## HISTORIC AND DESIGN REVIEW COMMISSION

June 07, 2017

**HDRC CASE NO:** 2017-265  
**ADDRESS:** 314 DONALDSON AVE  
**LEGAL DESCRIPTION:** NCB 1931 BLK 38 LOT 24  
**ZONING:** R-6  
**CITY COUNCIL DIST.:** 7  
**DISTRICT:** Monticello Park Historic District  
**APPLICANT:** Nathan Bailes  
**OWNER:** Maria Vargas  
**TYPE OF WORK:** Window Replacement  
**REQUEST:**

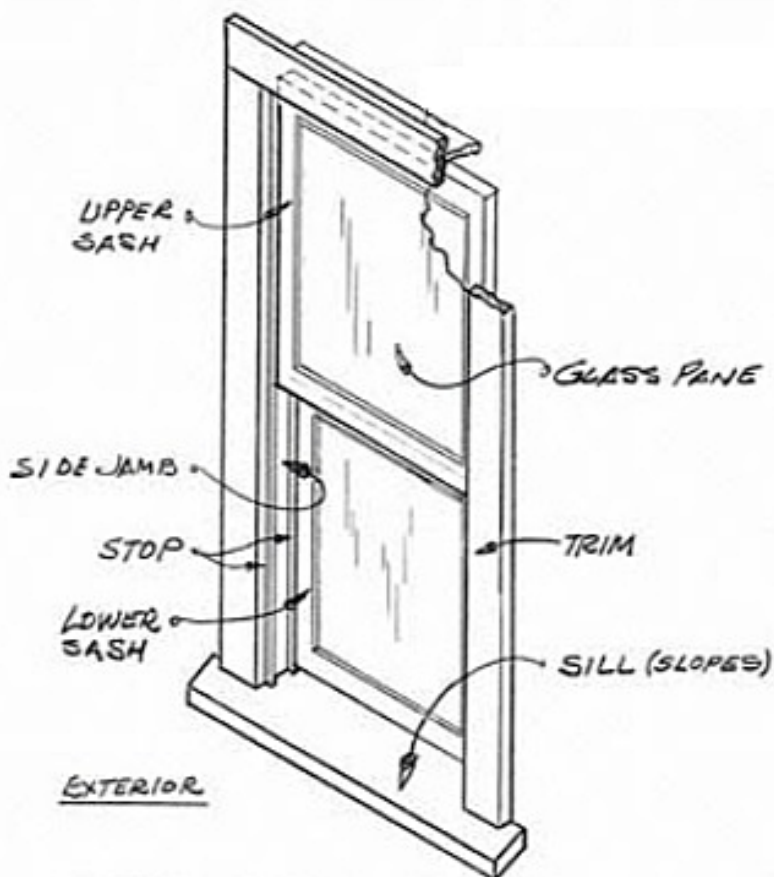
- The applicant is proposing to replace 3 wood one-over-one windows on the left façade, and one wood one-over one window on the right façade with new vinyl one over one windows with a wood trim around the opening to match the existing wood trim around the front wood windows. According to the Guidelines for Exterior Maintenance and Alterations 6.B.vii. and the *Guidelines for Windows*, historic windows if beyond 50% deteriorated, should be replaced with a window to match the original in terms of size, type, configuration, material and details, feature clear glass, and recessed within the window frame. The proposed vinyl windows with wood trim are not consistent in terms of material and installation, but are consistent in terms of configuration, size and glass type. At the site visit, staff found that these four windows are set towards the rear, but that they are still visible from the street. Staff finds that in-kind wood windows would be more appropriate per the Guidelines.

Staff does not recommend approval of items #1 through #3 based on findings a through h.
